**Subject: Planning & Urban Design Comments**  
Application No.: 19 243515 NNY 15 SA  
100, 110, 114 and 120 Broadway Avenue and 223-233 Redpath Avenue  
PLAN 806 PT LOTS 10 & 11  
Ward 15 - Don Valley West

These comments reference the drawings submitted for Site Plan Approval, date stamped by City Planning on **October 31, 2019**. Please find below Site Plan comments from City Planning, Urban Design and Transportation Planning regarding your application to permit 3 towers.

# Appendix 2: Broadway Avenue Typical Section

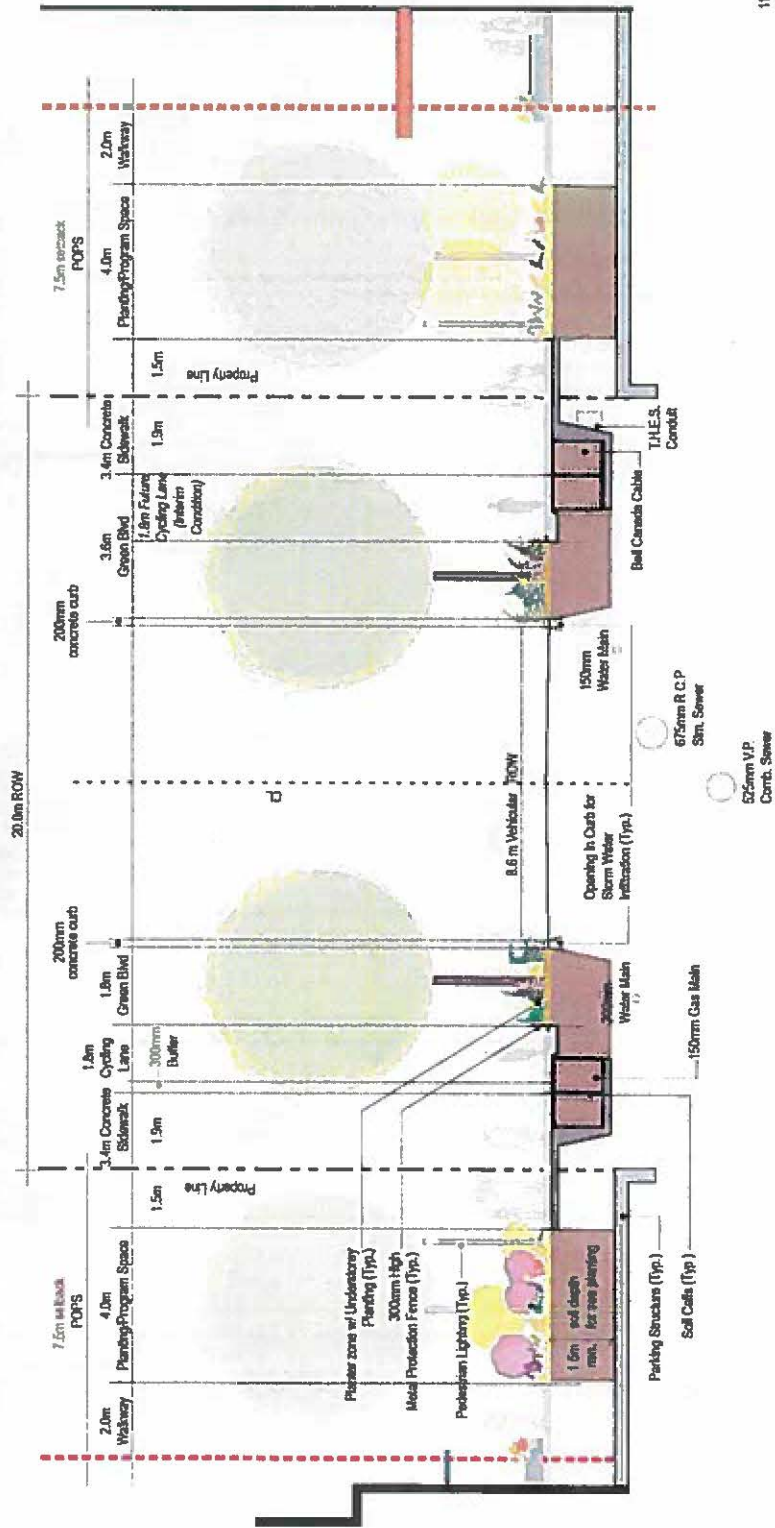
18. As part of the implementation of Midtown in Focus, staff will be implementing the Park Street Loop on both sides of Roehampton and Broadway Avenues. Please see Appendix 2 and 3 for general sections of the Park Street Loop.
19. Staff request that the applicant find a location for a dog relief area. This is an important consideration in tall buildings and the urban Midtown context. Any area should be provided with irrigation or a hose bib.
20. Please provide an irrigation plan or other watering source for green roof and planting areas. Please clearly indicate hose bibs on the green roof areas and large planting areas within the outdoor amenity area(s).
